AGENDA

PLAN COMMISSION

Plan Commission: November 18, 2024 at 7:00 PM

FINAL ENGINEERING PLANS
FOR
HERITAGE CROSSING
5600 SOUTH WOLF ROAD
WESTERN SPRINGS, ILLINOIS

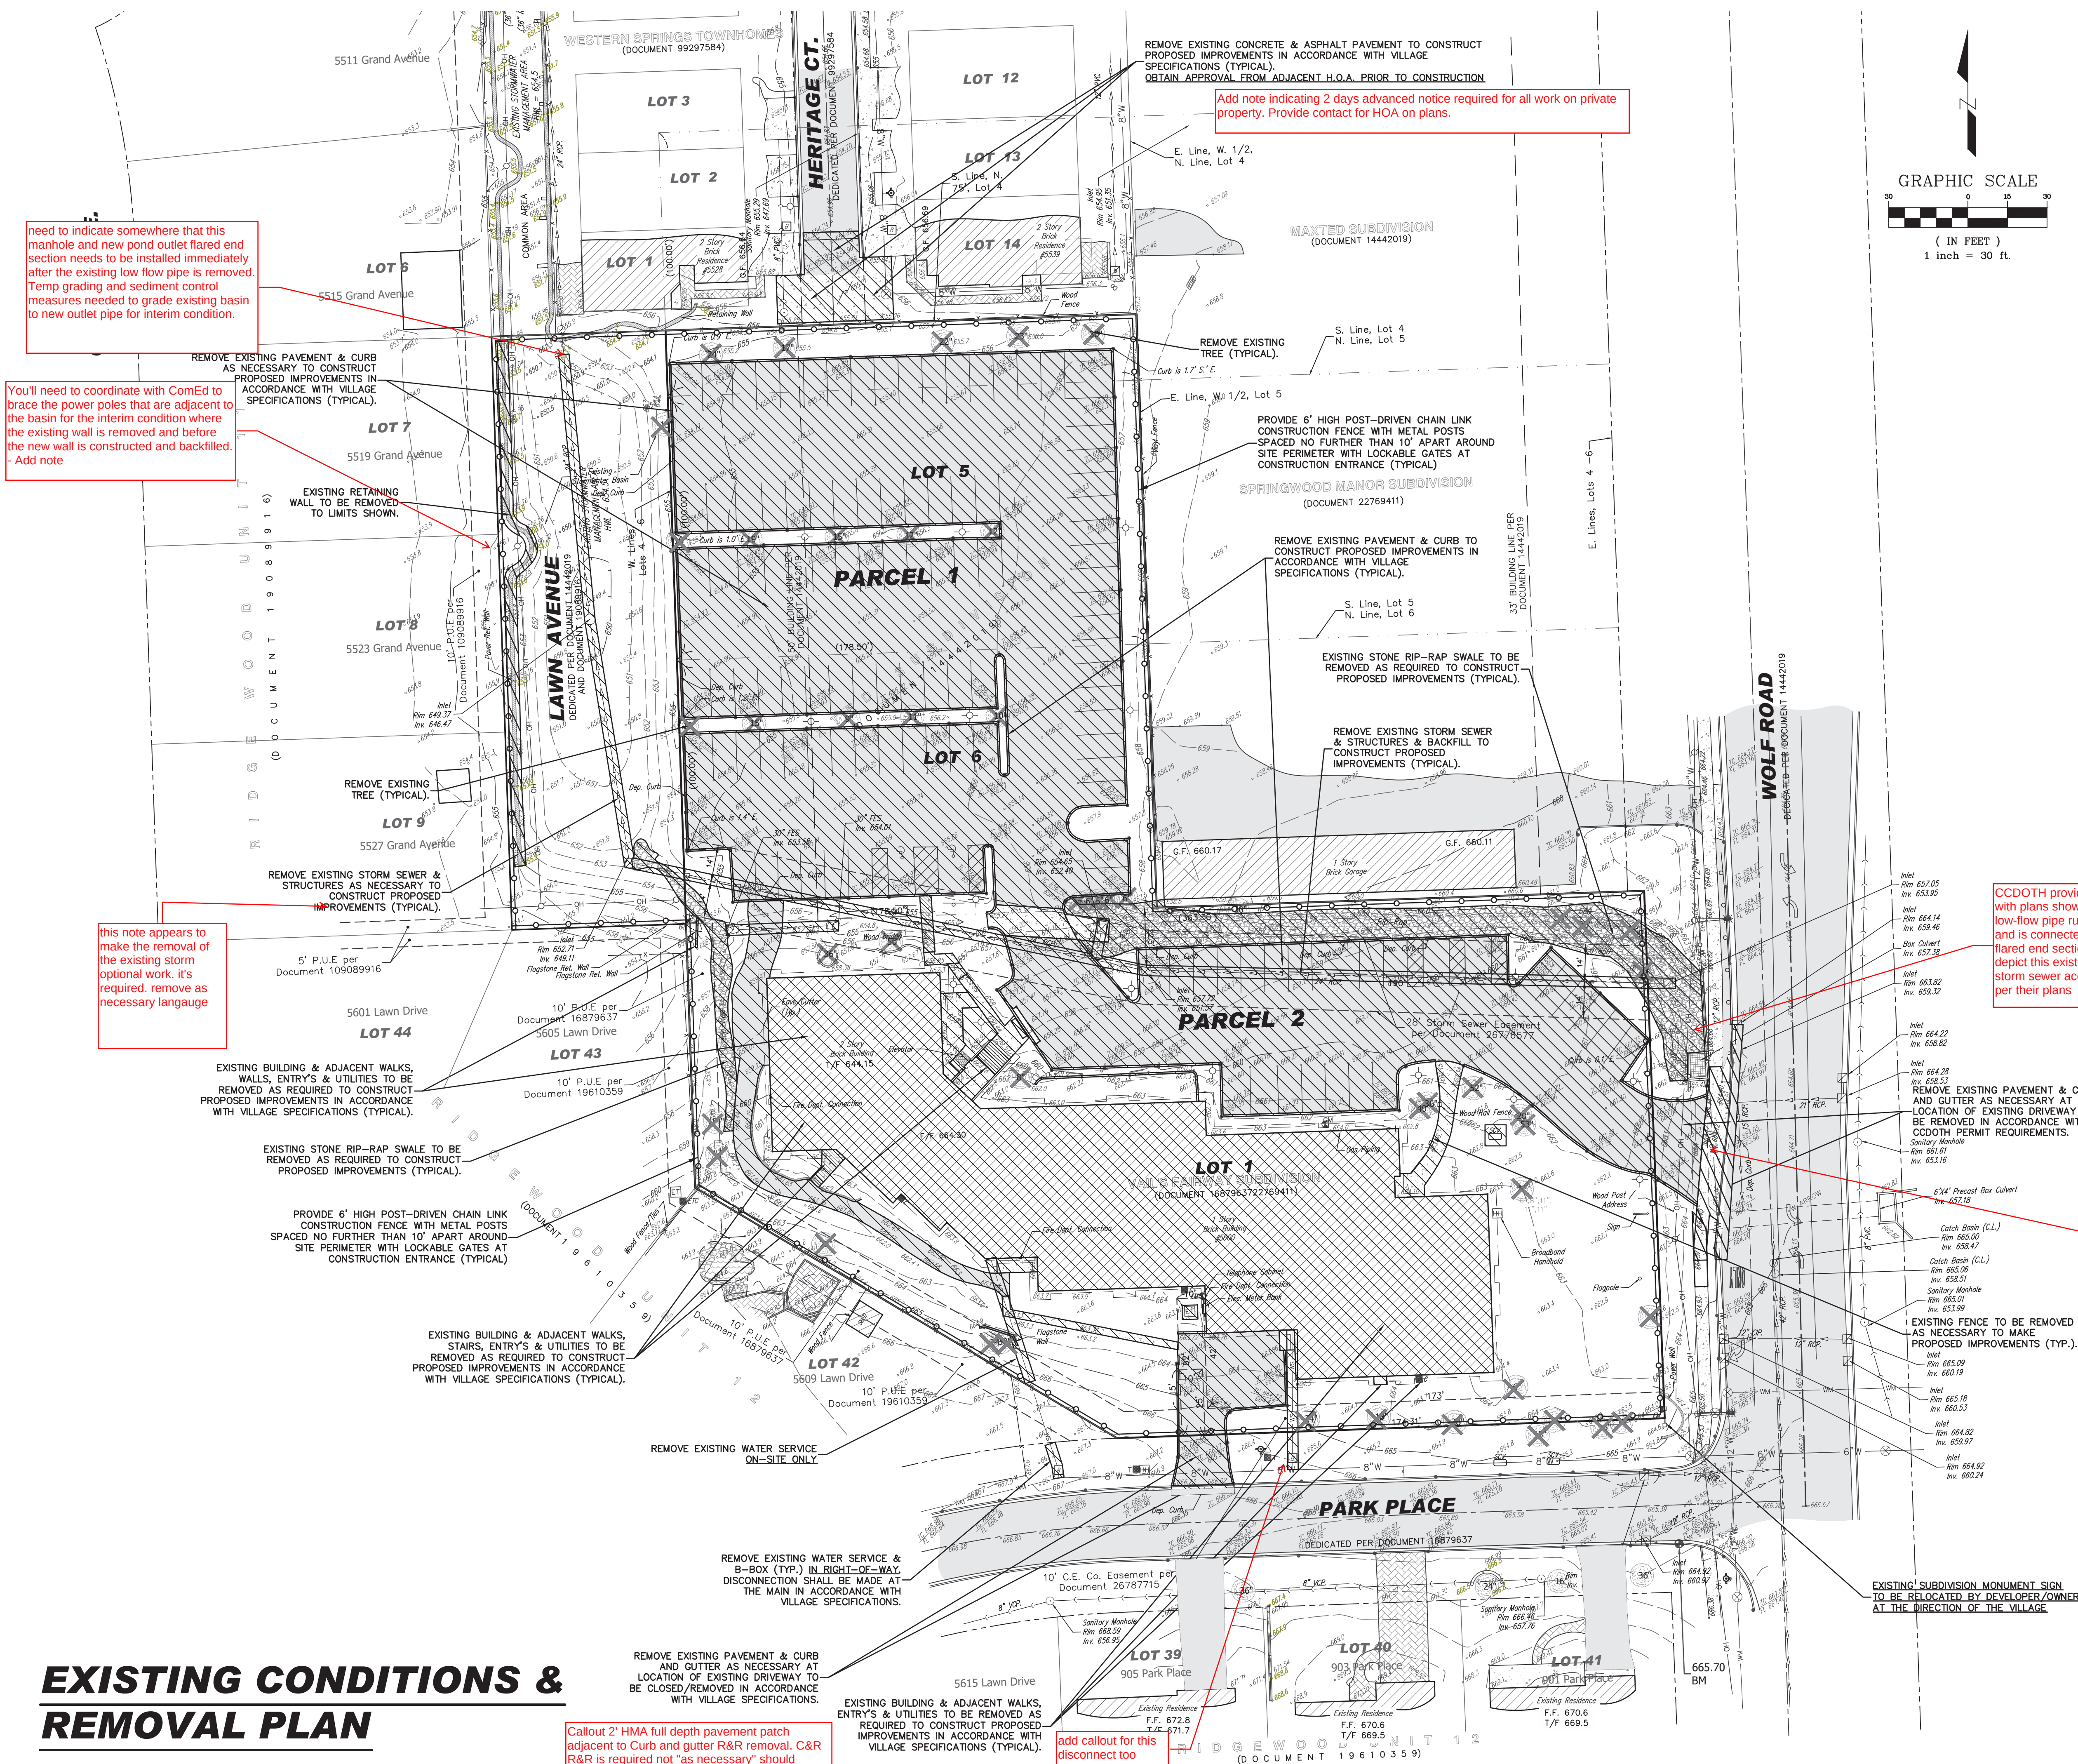
add callout for this disconnect too

GEOMETRIC PLAN

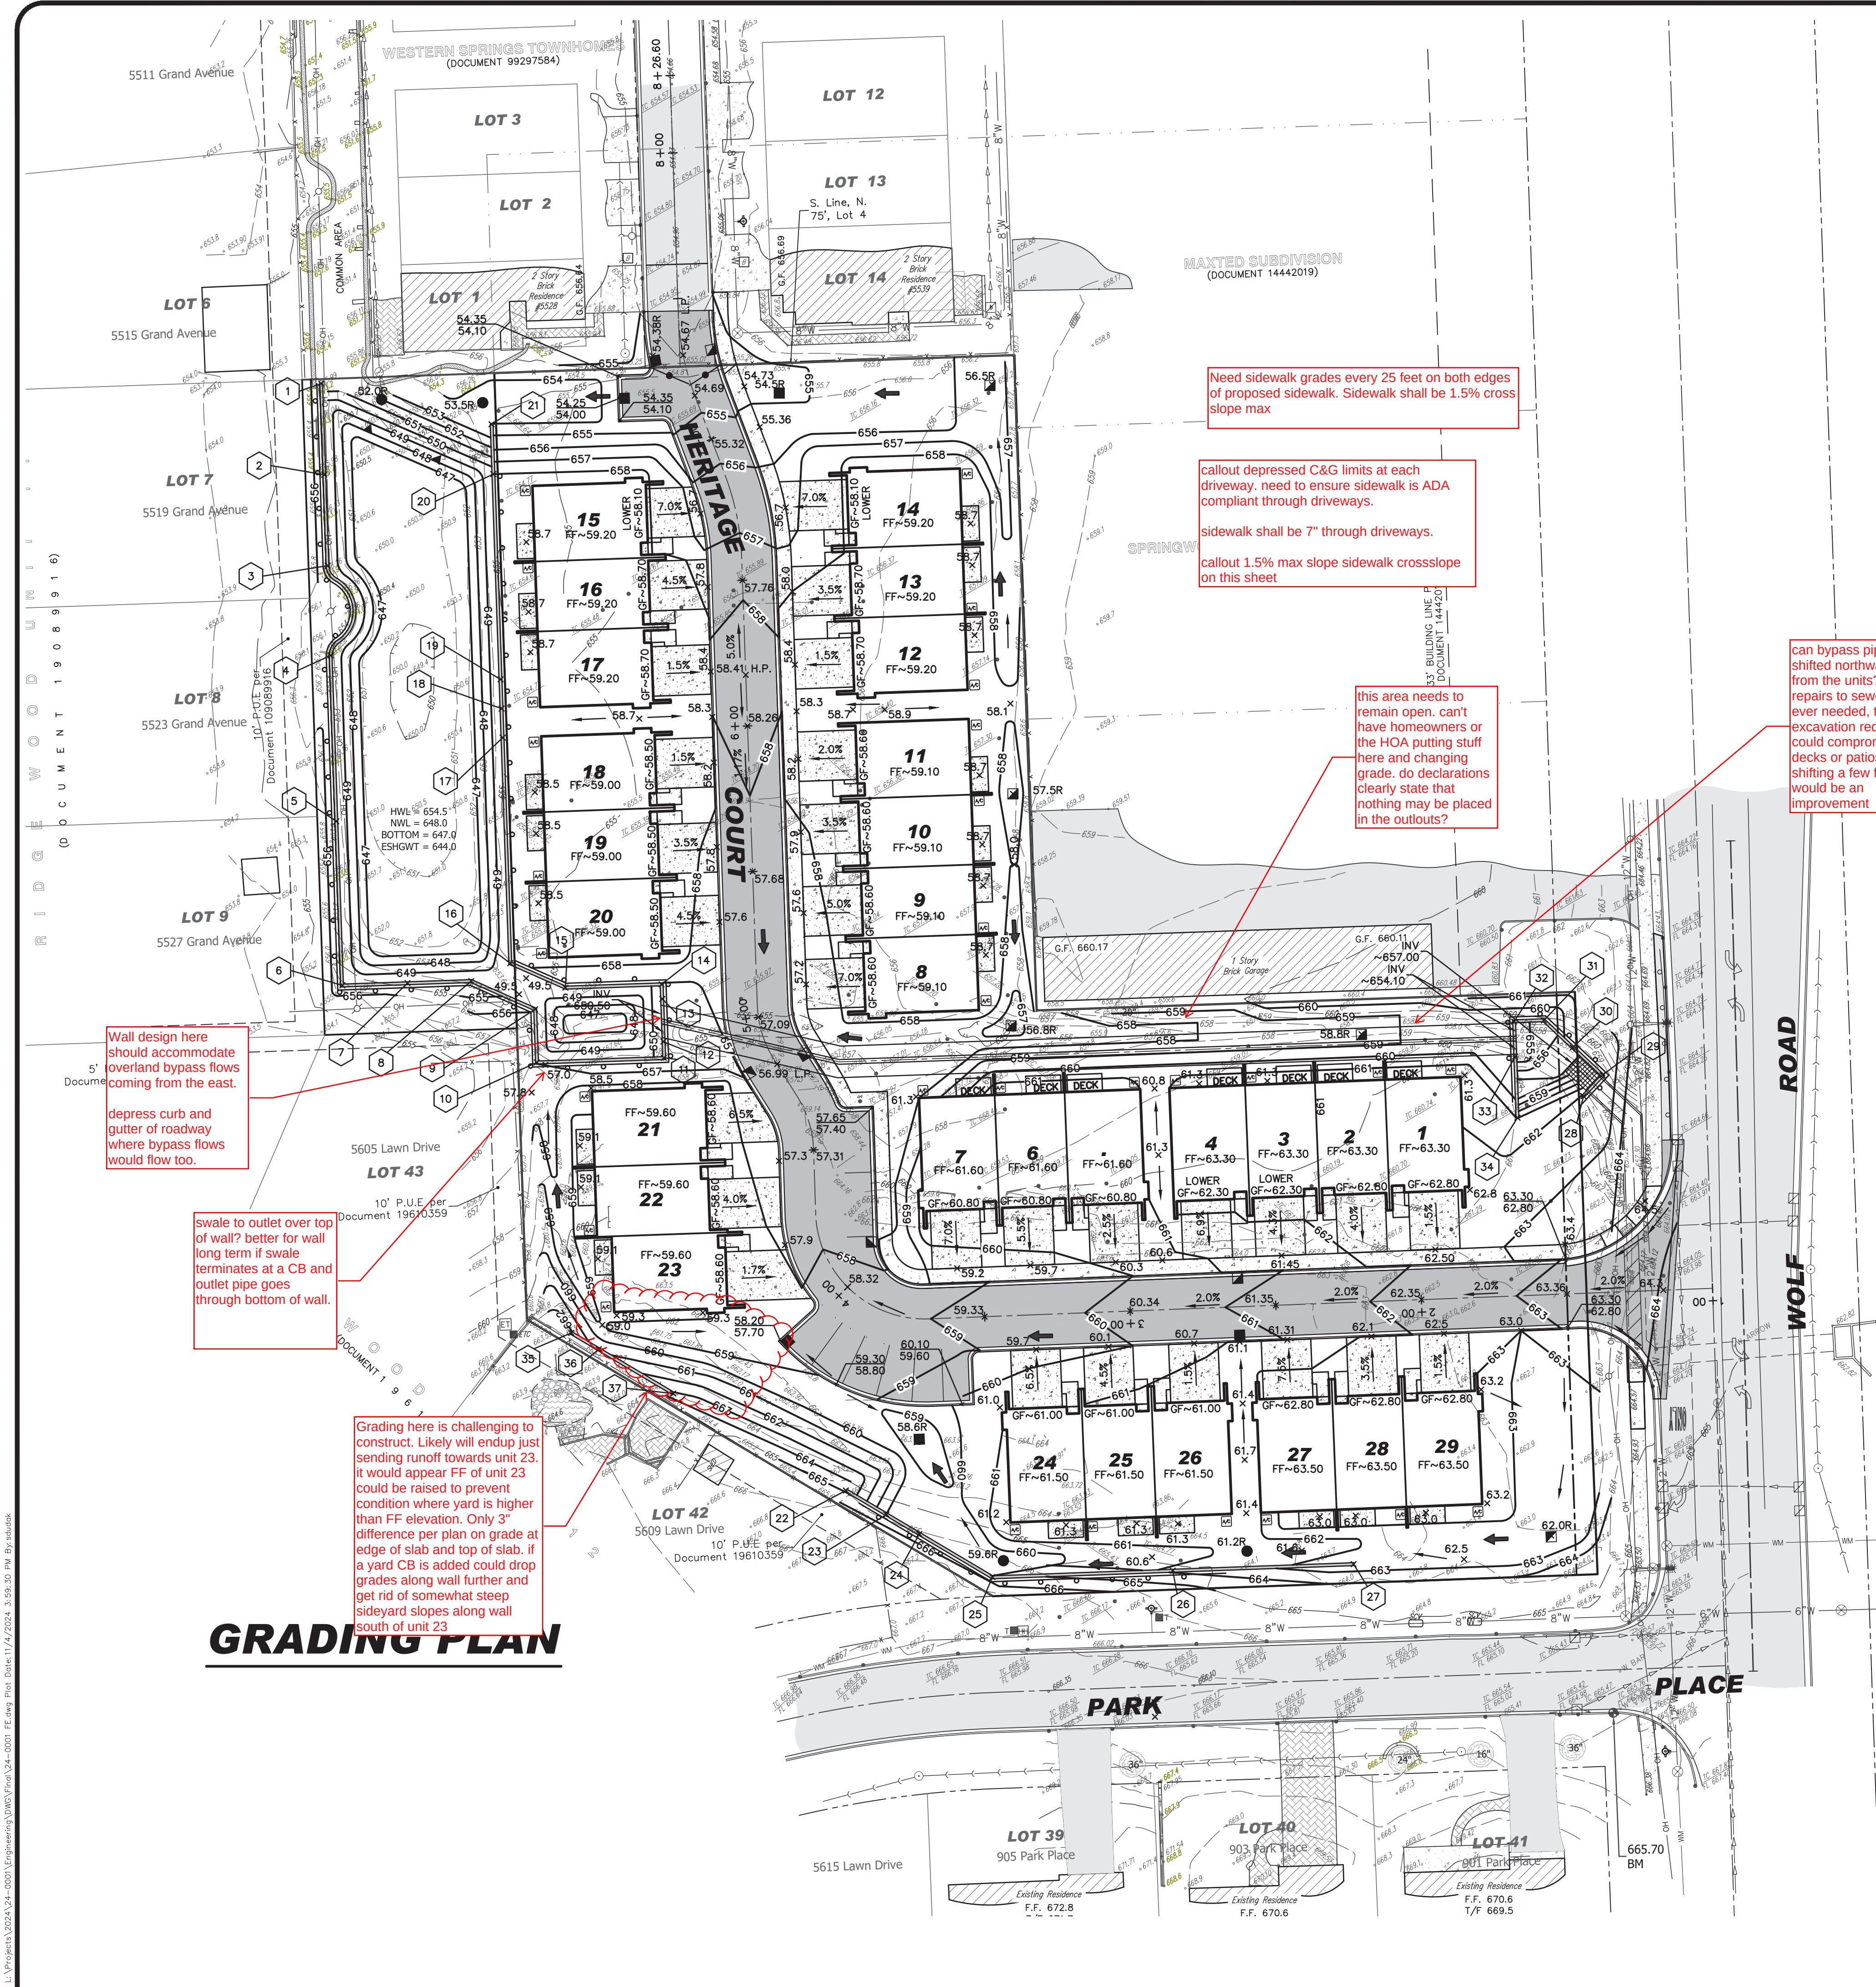
- 02-6 Sheet 7 of 16 Geometric Plan – The offsite parking stalls being constructed on Heritage Estates HOA property also need either a temporary easement or an agreement from the HOA allowing the work. I could not locate proposed grading plan for this new parking area in the plan set. How is drainage being handled? It appears the existing west curblin of the street is barrier curb in this location so that curb and gutter will need to be removed and possibly (depending on proposed grading) need to be replaced with depressed curb and gutter. Any removal and replacement of curb and gutter will require a 2 foot HMA surface pavement patch as well. Show the new proposed location of the mailbox on the plans. Include a detail for the mailbox foundation. Perhaps a detail was included in the original subdivision plans. The mailbox needs to be installed in accordance with the United States Post Office regulations for height and offset from road.

UTILITY PLAN

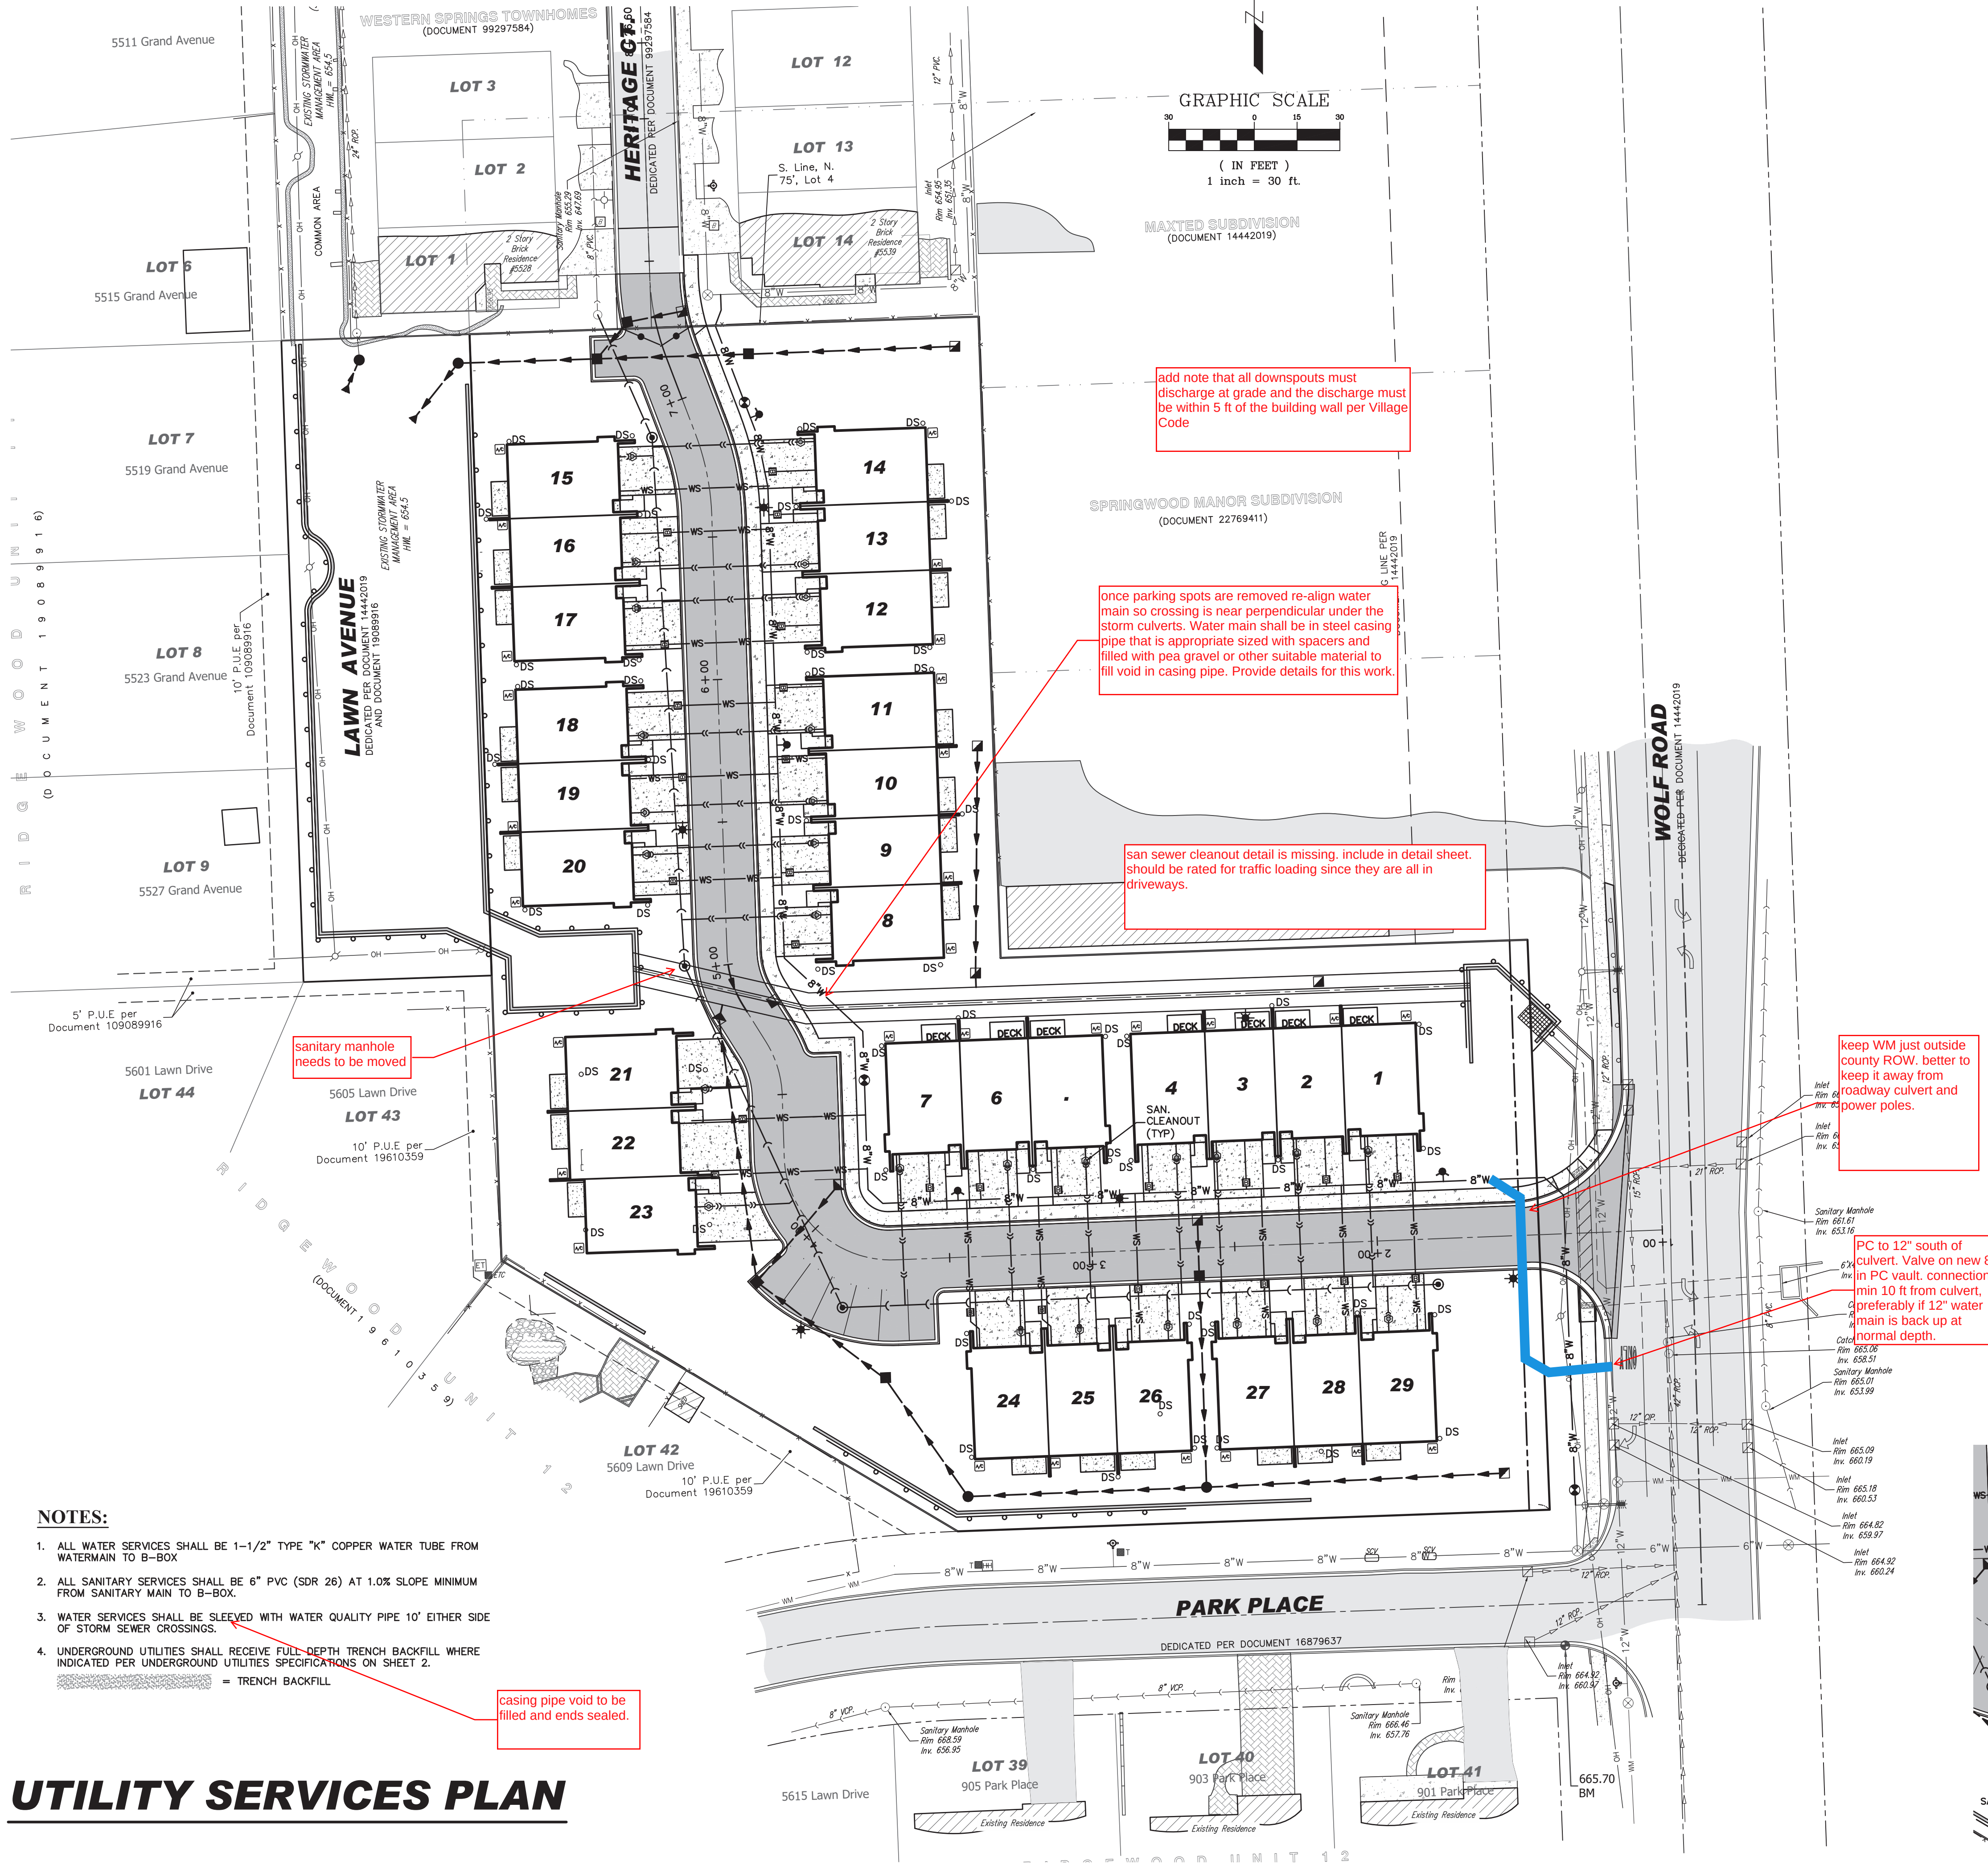
add note that all downspouts must discharge at grade and the discharge must be within 5 ft of the building wall per Village Code
